Appendix D – EOR Monthly Dam Inspections

Myra Falls Mine Tailings Facility Field Review Report

Date of Field Review:	21 January 2019	Date of Memo:	24 September 2019
File No.:	NX14001B1	Client:	Nyrstar Myra Falls Ltd.
Engineer:	Dan Hughes-Games, P.Eng.	To:	Keith Watson, P.Eng.
With:	n/a	Cc:	
Weather:	Sunny, few degrees below zero. Most of site in shade of Mt. Myra throughout the day. Discontinuous snow cover on site, particularly in the shade.

Photo 5: Lynx TDF pumping area. Water level at 0.71 m on the gauge, 355.02 m elevation.

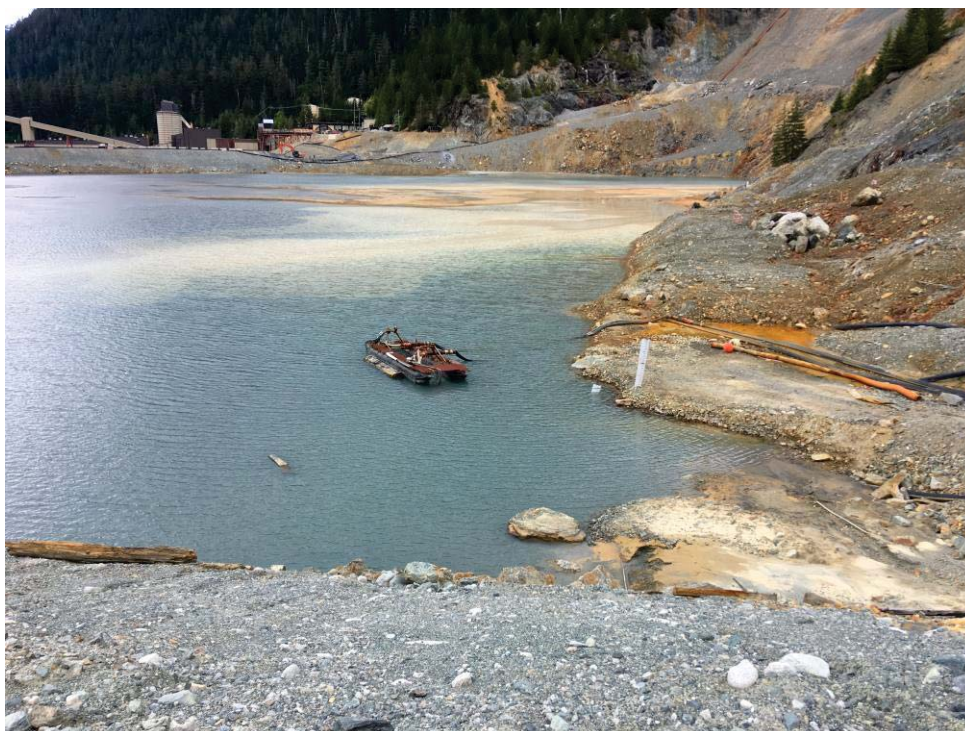
- Water level is at 0.71 on the staff gauge (355.02 m), 2 cm above maximum Normal Operating Water Level.
- Sinkhole is visible in similar location and size as the inspection of 04 April 2019.
- Reviewed the dam crest for cracking. Cracking near Plane F consistent with prior observations. No additional cracking noted.
- Minor areas of puddling at the dam toe, mainly Panel 7 and 13. No significant seepage or runoff at the toe.
- Downstream slope appears as constructed. No sags/cracks/bulges.
- Twin tails line was freshly broken at the time of the inspection, discharging clear water on the dam crest at the west abutment. Repairs were underway.

Photo 8: Indications of upwelling groundwater at the upstream toe of Lynx TDF construction, in response to consolidation (22 July)

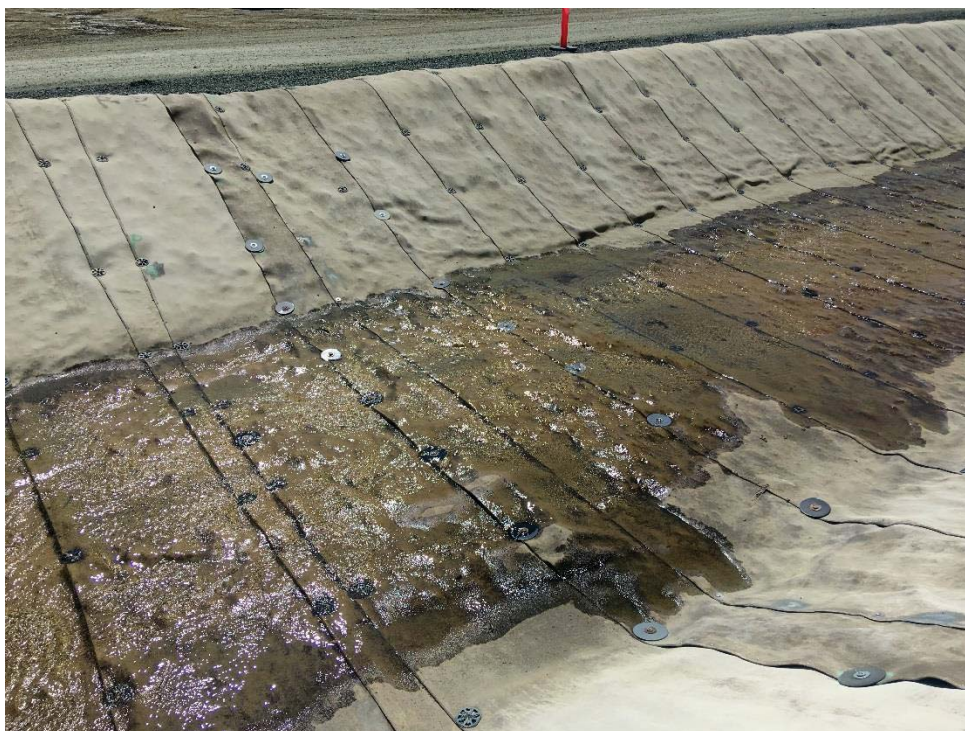
- The sinkhole is visible in a location and size consistent with recent observations (all dates noted above).
- Work is underway to place a platform for the upstream beach. Fill placement is resulting in significant displacement of dredgate, and a mud wave approximately 50-100 m wide. There are indications of upwelling groundwater in response to consolidation at the toe of the fill.

Photo 13: Example of a tear in the Superpond liner, this one just east of the primary outlet.

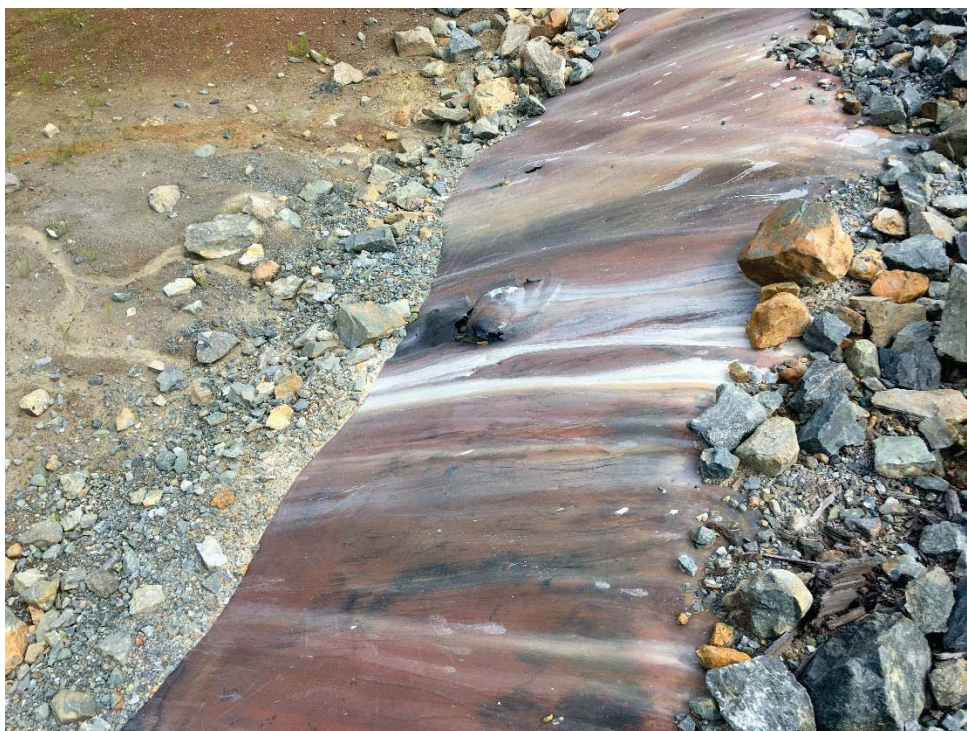
- The HDPE liner is generally in good condition, but has several significant tears above the normal water level on the south side, and a number of minor tears or punctures elsewhere. Liner repairs should be undertaken.
